AMERICAN FORK CITY
NOTICE OF PUBLIC HEARING
PLANNING COMMISSION REGULAR SESSION
January 4th, 2023
7:00 p.m.

AMERICAN FORK CITY
PLANNING COMMISSION

MEETING DATE: January 4th, 2023

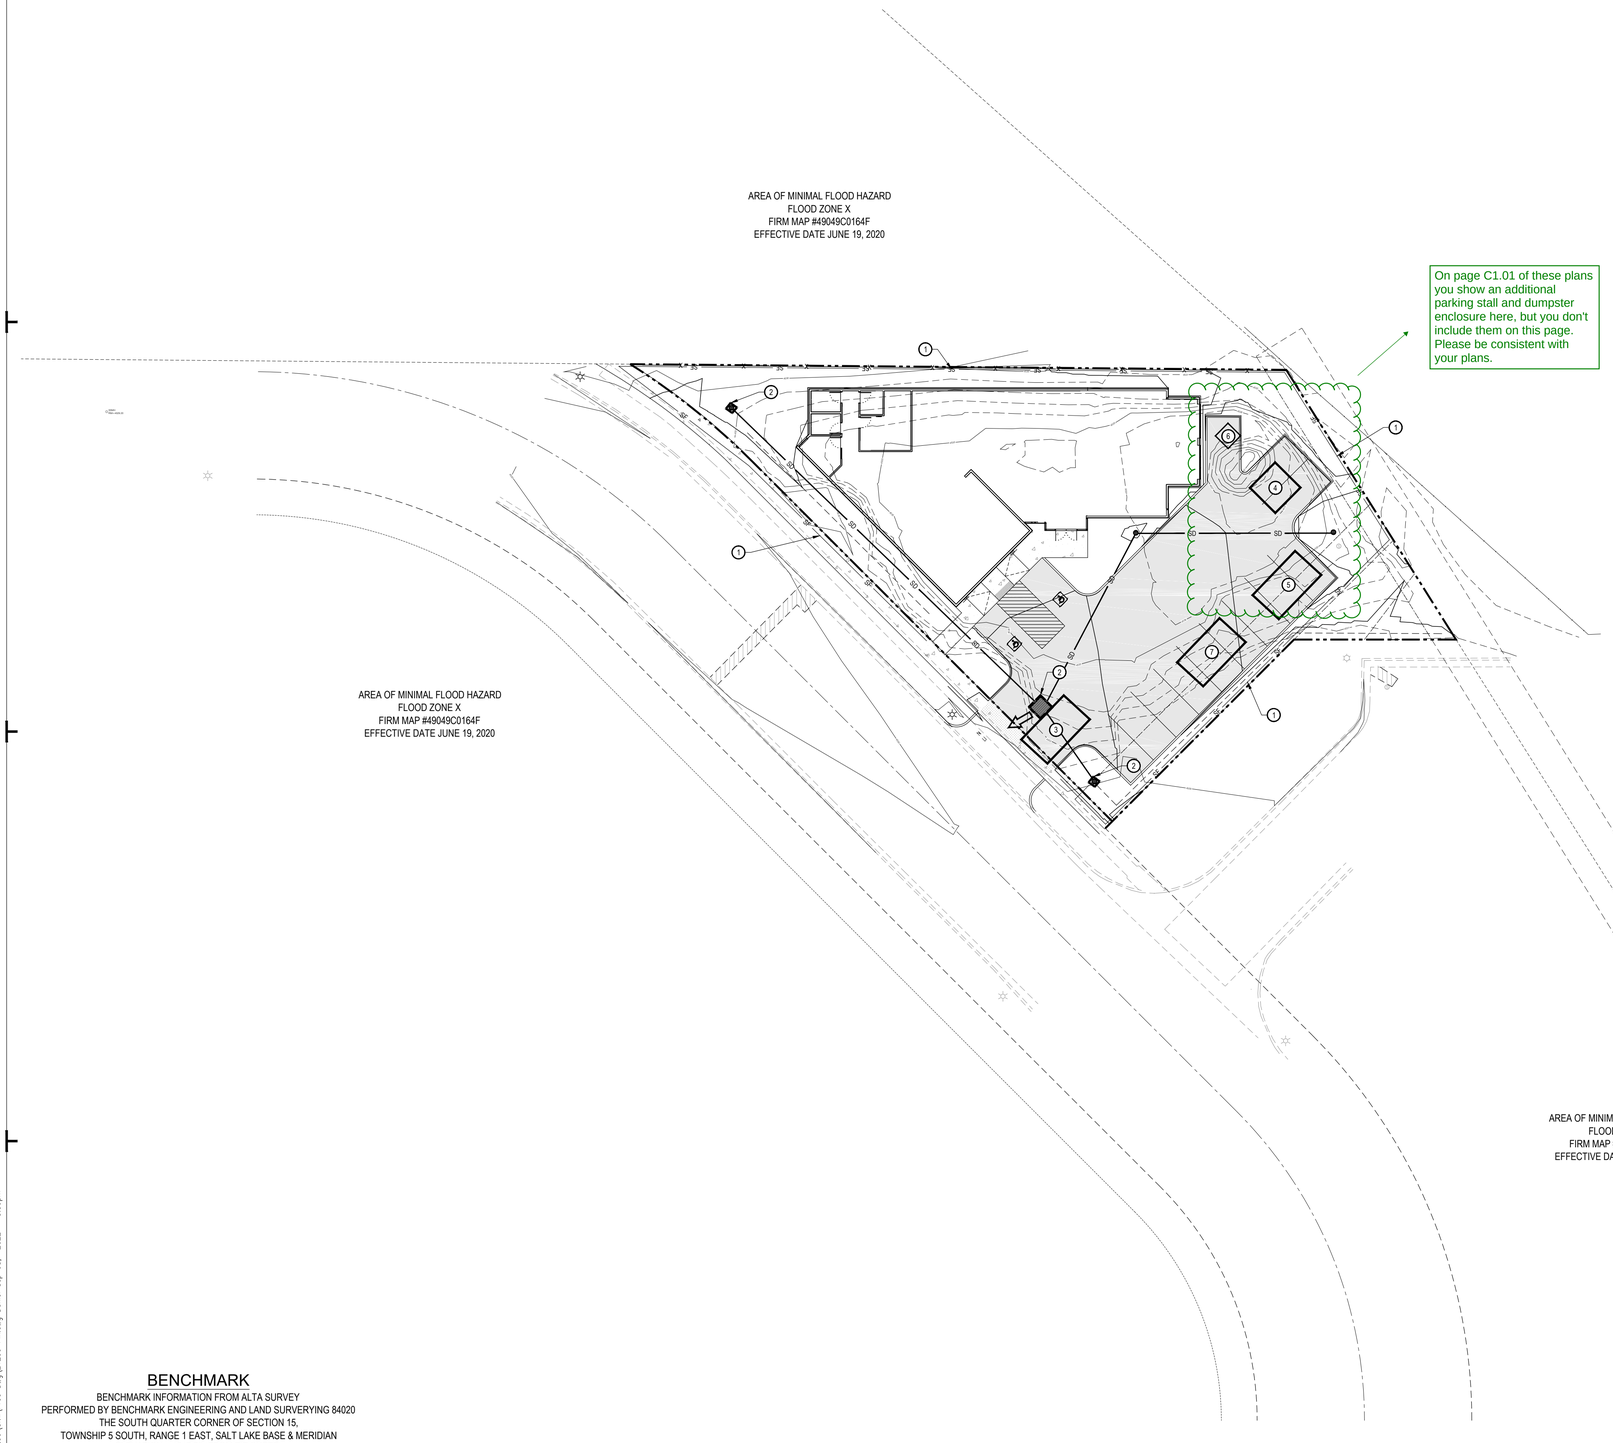
On page C1.01 of these plans you show an additional parking stall and dumpster enclosure here, but you don't include them on this page. Please be consistent with your plans.
